# TOWNSHIP OF ABINGTON

## ADMINISTRATIVE CODE AND LAND USE COMMITTEE

- a. **ACL-01-061319** Consider a motion approving the Switchville Crossing Planning Module and adopting Resolution 19-020 for Plan Revision for New Land Development, including the Transmittal Letter for Planning Module.

Switchville Crossing Planning Module - Duke Real Estate Partners, LLC - Located at Highland Avenue, Wharton Road, Kenmore Avenue and Stewart Avenue, Jenkintown, PA

**FINAL RECORD PLAN SITE PLAN**  
 OF  
**PROPOSED AUTOMOTIVE SALES FACILITY**  
 1501, 1505,  
 1509 AND 1515 EASTON ROAD

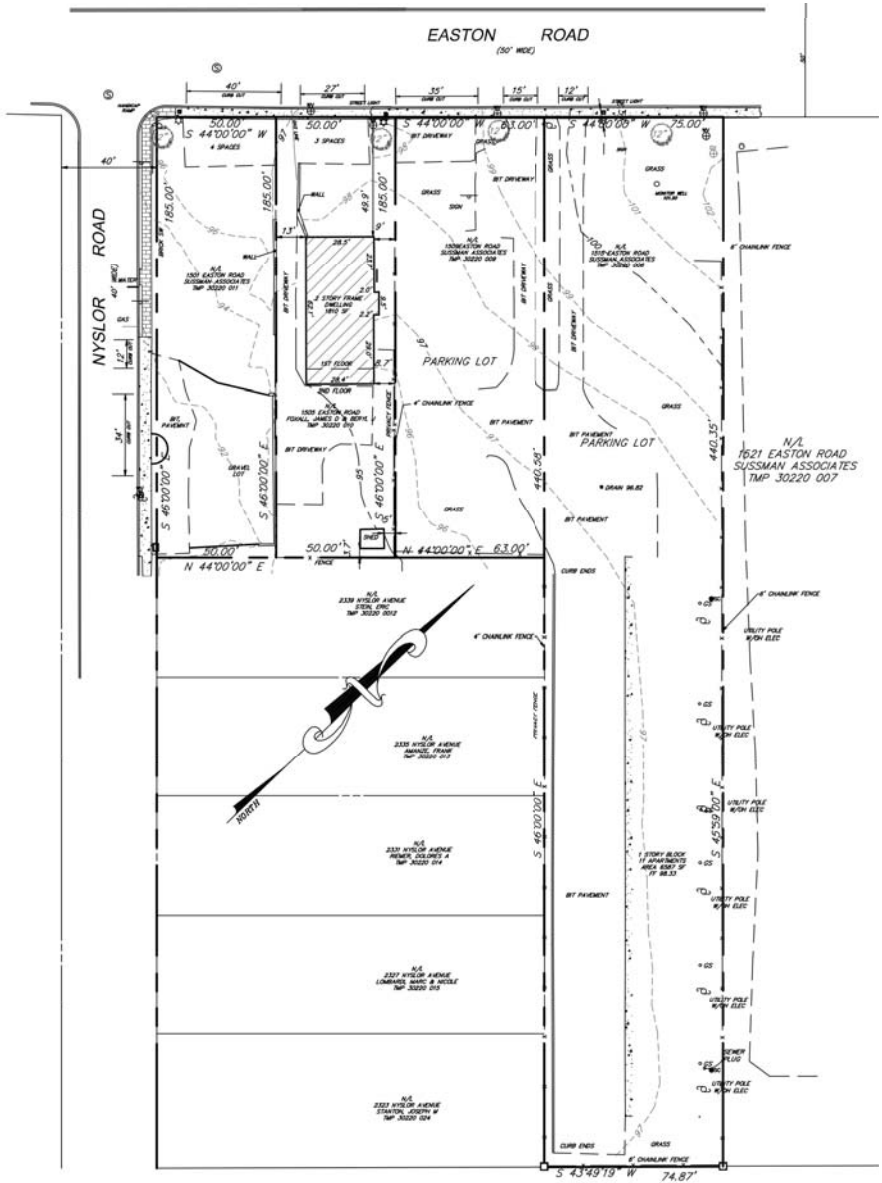
57. Fifteen (15) foot easements are labeled along Nylsor Avenue and Easton Road on Sheet 1 of the Land Development Plan. The purpose of the easements must be noted on the plan.

58. On Sheet 1 of the Land Development Plan, the Abington Township Engineer signature block is not required and must be removed from the plan.
  59. On Sheet 1 of the Land Development Plan, the handicap parking spaces are included in the customer parking space count in General Note 11. Therefore, the total number of provided parking spaces shall be corrected accordingly.

**FINAL  
SITE GRADING PLAN**  
OF  
**PROPOSED AUTOMOTIVE  
SALES FACILITY**  
**1501 TO 1515 EASTON ROAD**

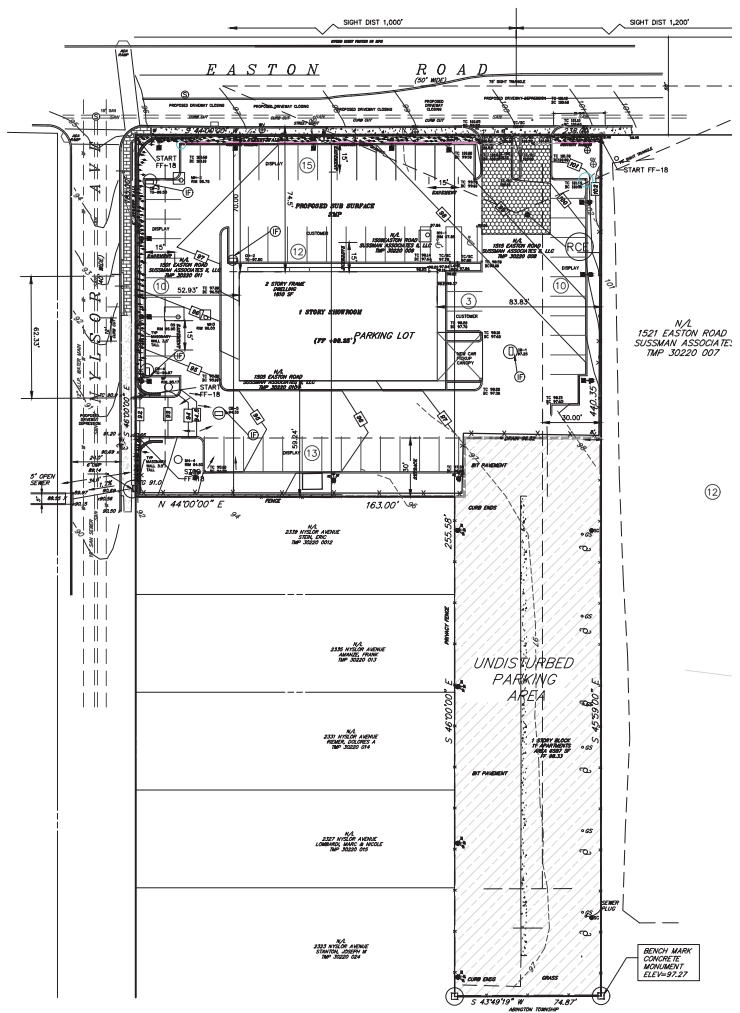
33. In accordance with Section 146-43.C.(1)(a), the proposed grading shown on Sheet 4 of the Land Development Plan and to the north of the proposed building shall be revised to maximize the slope and to ensure stormwater flows toward inlet CB-2 without ponding.

**FINAL LANDSCAPING & LIGHTING PLAN**  
OF  
**PROPOSED AUTOMOTIVE SALES/SERVICE FACILITY**  
1645 TO 1675 EASTON ROAD

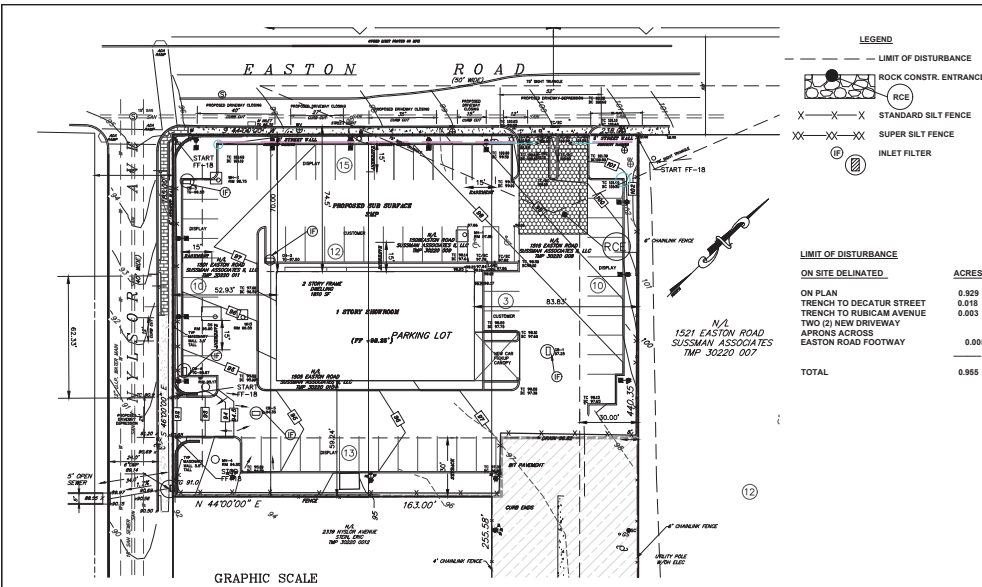
66. A Parking Curb Detail is shown on Sheet 4 of the Land Development Plan. The locations of the parking curbs must be shown in plan view.
67. On Sheet 5 of the Land Development Plan, the property address in the title block is incorrect and must be revised. In addition, it does not appear the plan date is correct on Sheet 5 and should also be revised.

68. The proposed and existing utilities must be shown on Sheet 5 of the Land Development Plan to determine if any conflicts with the proposed landscaping or lighting will occur.

**FINAL EROSION CONTROL PLAN**

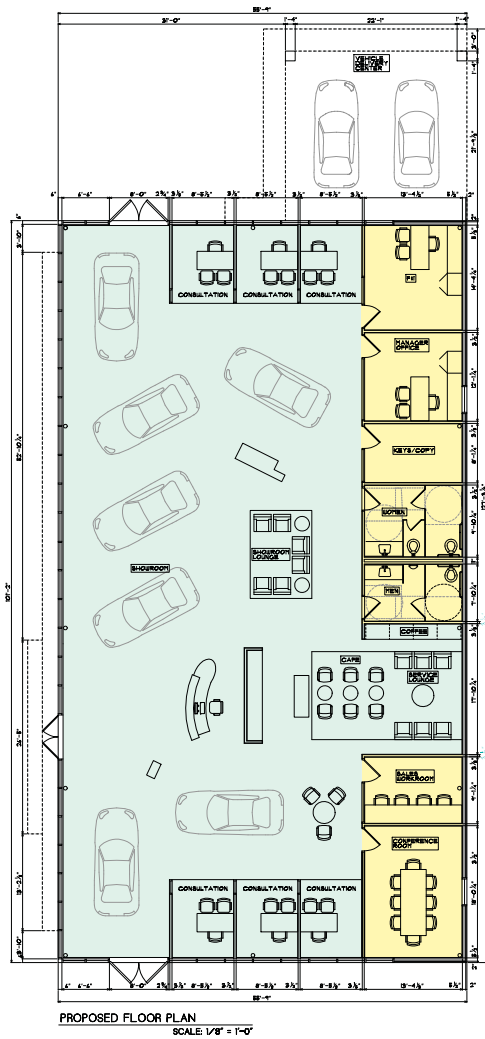
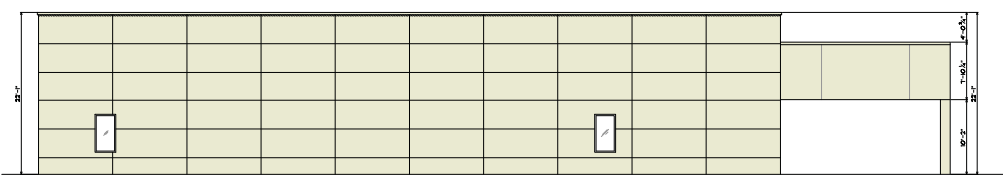
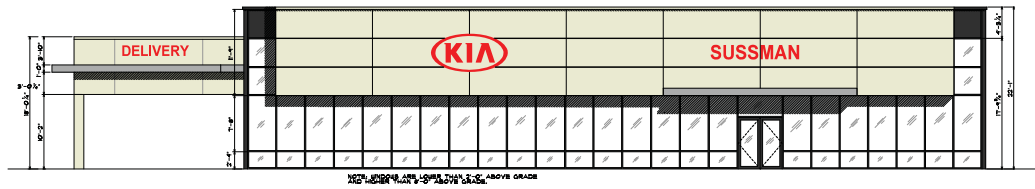
- h. The Soil and Erosion Control Narrative provided on Sheet 5 references a service facility. A service facility is not proposed as part of this project and is not permitted per the conditions of the granted variances.

Annotated Plan

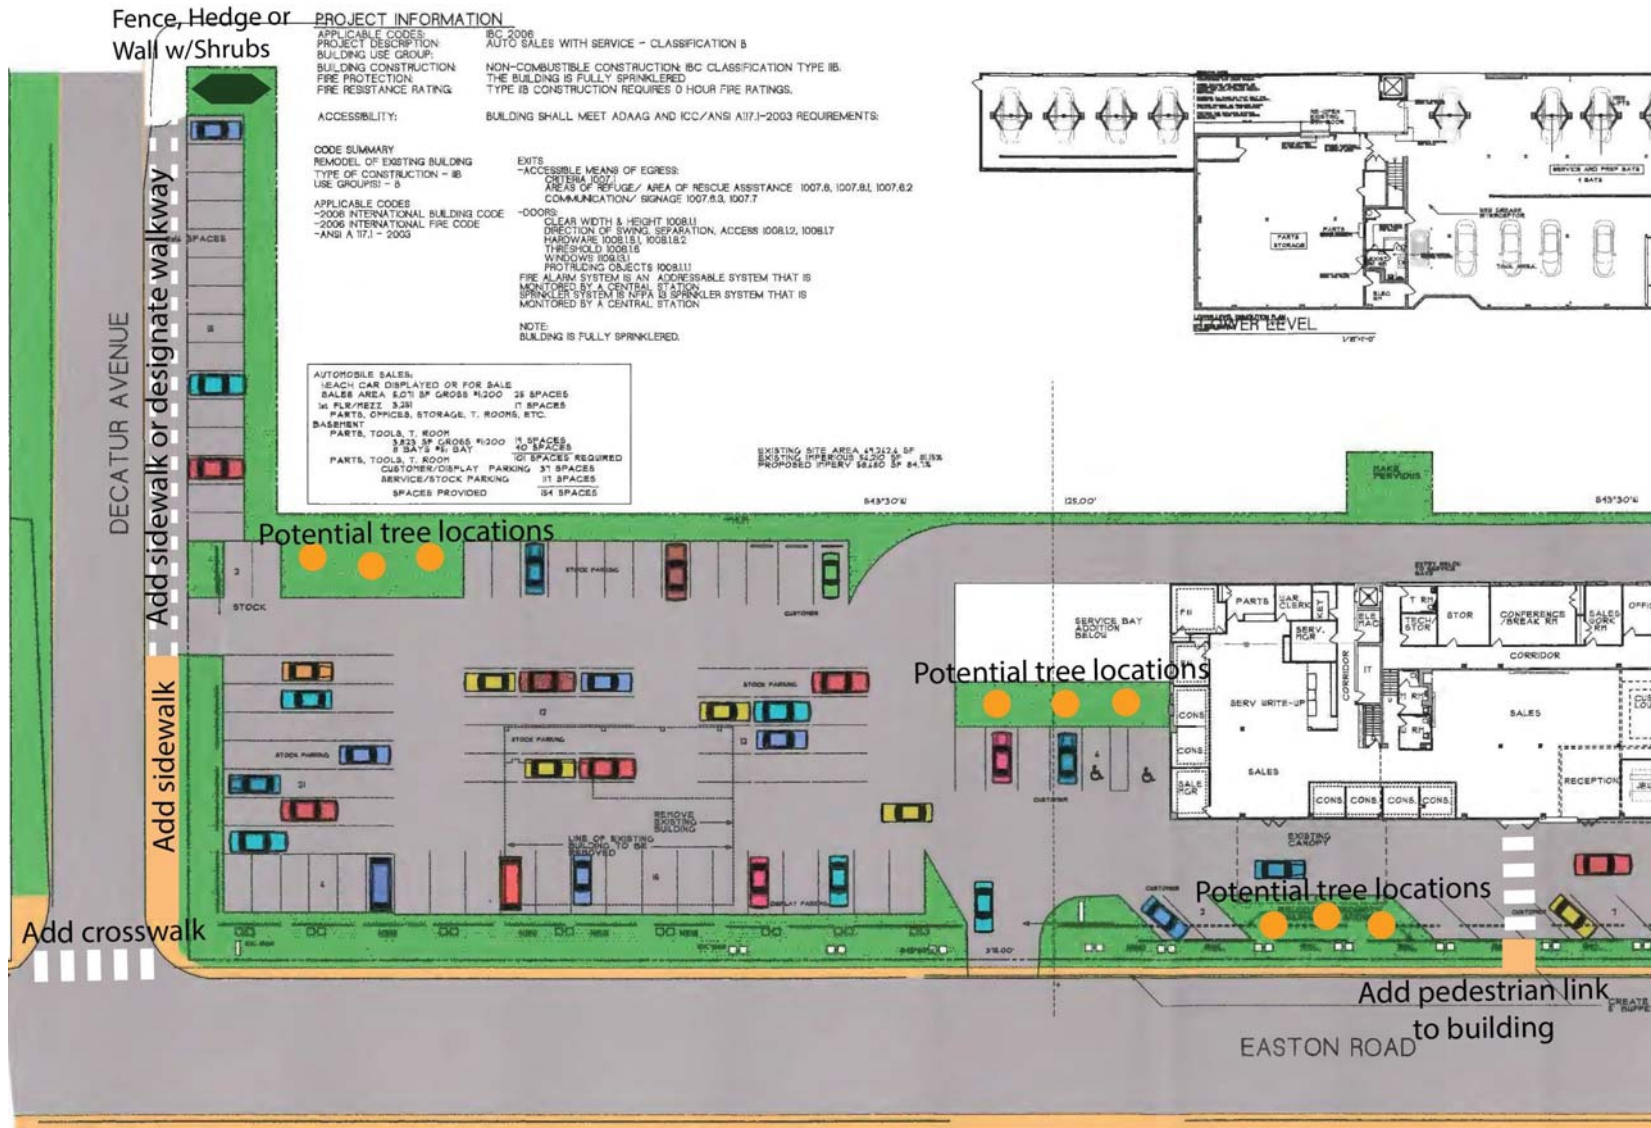
- A. Crosswalks. We recommend adding a crosswalk over Decatur Avenue at Easton Road [§146-27].
- B. Sidewalks. A sidewalk is required along the Decatur Avenue frontage. This section of Decatur Avenue connects the Easton Avenue commercial and mixed-use area with the Crestmont neighborhood; a sidewalk here would improve pedestrian connectivity and safety [§2504.D, §146-27].

- C. Building Connection to Street. In the Main Street Districts, all buildings shall be connected, by a continuous pedestrian system of crosswalks and sidewalks, to the street [§2504.C].
- D. Streetfront Sidewalk: shall be at least eight feet (8') wide [§2504.C].
- E. Verge: The street sidewalk shall be separated from the sidewalk by a verge of at least three feet (3') in width [§2504.E].

- A. A list of plantings shall be provided [§146-11.H.].
- B. Screening. A medium-intensity screen is required for vehicle storage [Zoning Figure 24.7]. Options include a hedge, a masonry wall with shrubs or an opaque fence meeting the requirements of §2403. Buffers and Screens (Subsection C).
